June 11, 2014

ADDENDUM NO. 2

NDOR – Chappell Shop and Storage Building Electrical Upgrade
NDOR Bldg. No. 50601
AFE I-529
OA Project No. 013-0679

ELECTRICAL ONE-LINE DIAGRAMS

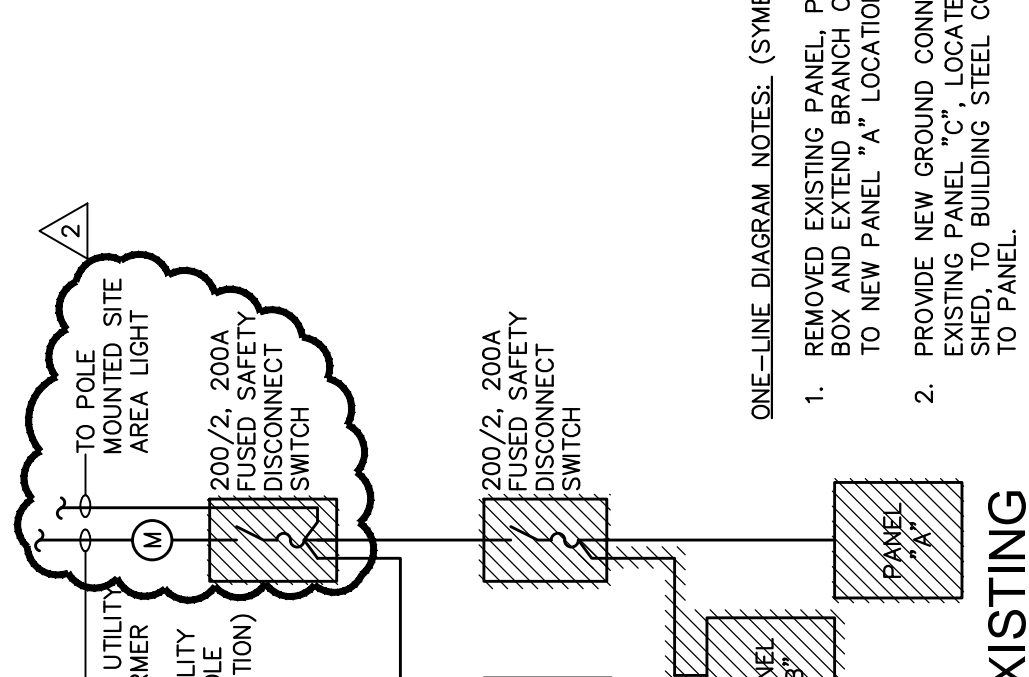
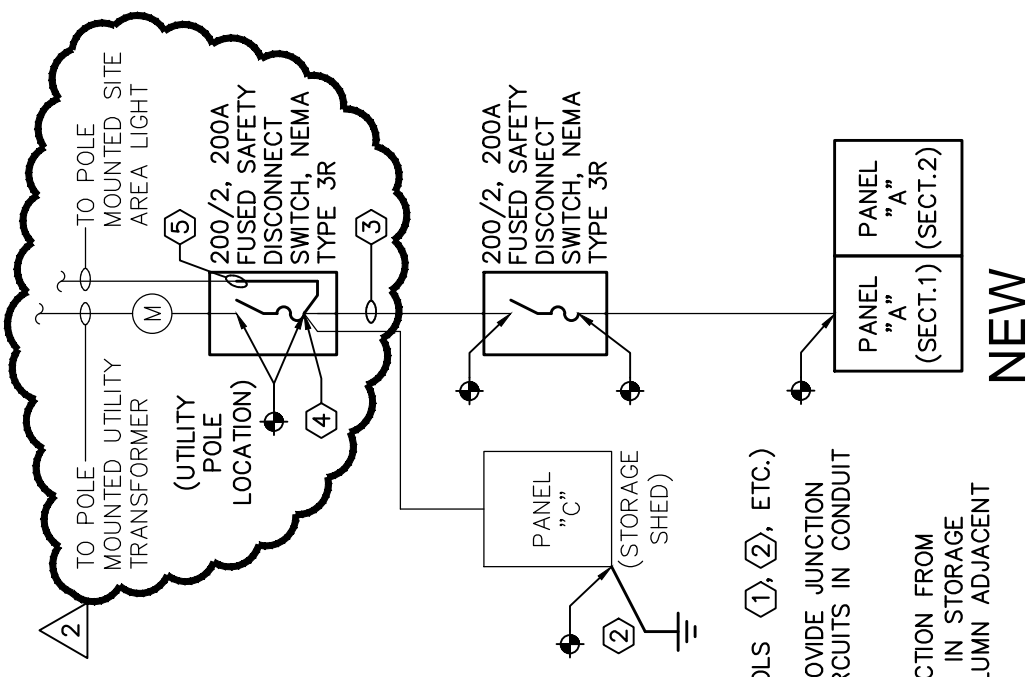
1. Clarify existing electrical connections at existing 200/2 safety disconnect, to include existing pole mounted lighting circuit. Lighting circuit to be reconnected to new safety disconnect, refer to One-line Diagram Note 4 and added Note 5. (See attached sketch ME1.1-1.)
2. Add Sheet Note 9 to clarify raceway for existing office area with new devices mounted at block walls. (See attached sketch ME1.1-2.)

1. REMOVED EXISTING PANEL, PROVIDE JUNCTION BOX AND EXTEND BRANCH CIRCUITS IN CONDUIT TO NEW PANEL "A" LOCATION.
2. PROVIDE NEW GROUND CONNECTION FROM EXISTING PANEL "C", LOCATED IN STORAGE SHED, TO BUILDING STEEL COLUMN ADJACENT TO PANEL.
3. PROVIDE NEW EXPANSION SLIP CONDUIT FITTING IN RISER FROM UNDERGROUND CONDUIT TO DISCONNECT ON UTILITY POLE.
4. PROVIDE LUGS FOR EACH CONDUCTOR.
5. EXTEND EXISTING POLE MOUNTED AREA LIGHTING CONDUCTORS AND PROVIDE IN-LINE FUSING.
